Access Compliance Report Public Rights-of-Way (Curb Ramps)

Main Street: BLAKEMORE_DR		Cross Street: KEMPTON_LN		Location:	E
ADA ID: RPRK211021144221	Ramp Type: Type 4 - Parallel	Initial Pass/Fail: Fail	Overall Compliance: No	Severity Score:	16

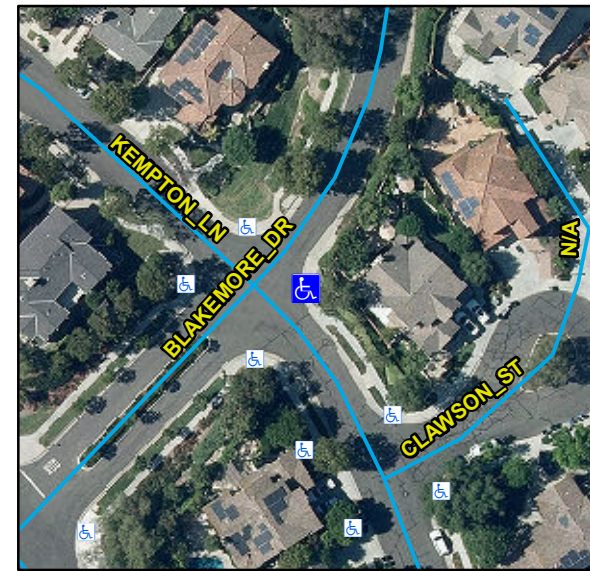
Compliance	Description	Data	Compliance	Description	Data
N/A	Ramp Length LT (in)	116	N/A	Ramp Length RT (in)	111
Yes	Ramp Width LT (in)	53	Yes	Ramp Width RT (in)	53
No	Ramp Run Slope LT (%)	8.7	Yes	Ramp Run Slope RT (%)	1.3
No	Ramp Cross Slope LT (%)	3.5	No	Ramp Cross Slope RT (%)	2.7
N/A	Landing Present	N/A	N/A	DWS Provided	N/A
N/A	Landing Length (in)	N/A	N/A	DWS Contrast	N/A
N/A	Landing Width (in)	N/A	N/A	DWS Length (in)	N/A
N/A	Landing Run Slope (%)	N/A	N/A	DWS Full Width	N/A
N/A	Landing Cross Slope (%)	N/A		DWS Offset Type	N/A
N/A	Landing Movement Obstructed?	N/A	N/A	DWS Offset Left (in)	N/A
	Landing Movement Type	N/A	N/A	DWS Offset Right (in)	N/A
N/A	Landing Shared	N/A			
N/A	Clear Space	Yes			
N/A	Clear Space To Crosswalk (in)	N/A			
N/A	Marked Crosswalk 1	No	N/A	Marked Crosswalk 2	No
	Crossing 1 Direction	NW		Crossing 2 Direction	SW
N/A	Marked Crosswalk 1 Width (in)	N/A		Marked Crosswalk 2 Width (in)	N/A

N/A	Ramp Inside Crosswalk 1	N/A	N/A	Ramp Inside Crosswalk 2	N/A
	Crossing 1 Slope (%)	0.7		Crossing 2 Slope (%)	7.2
	Crossing 1 Cross Slope (%)	4.4		Crossing 2 Cross Slope (%)	2.1
N/A	Gutter Ponding	N/A	N/A	Curb Slope	9.7
Yes	Gutter Lip Height (in)	0		Road Run Slope (%)	3.9
N/A	Gutter Run Slope (%)	N/A		Road Cross Slope (%)	4.1
N/A	Gutter Cross Slope (%)	N/A	No	Perpendicular Joint Present	No
Yes	Overall Surface Condition	Acceptable			
	Cross Gutter Present?	No		Spandrel Present?	No
	Replace Cross Gutter?	N/A		Replace Spandrel?	N/A

Remove & Replace Curb Ramp With Two New Directional Ramps or Equivalent.

R204.3, R304.3.2, R304.5.3, STD 1115
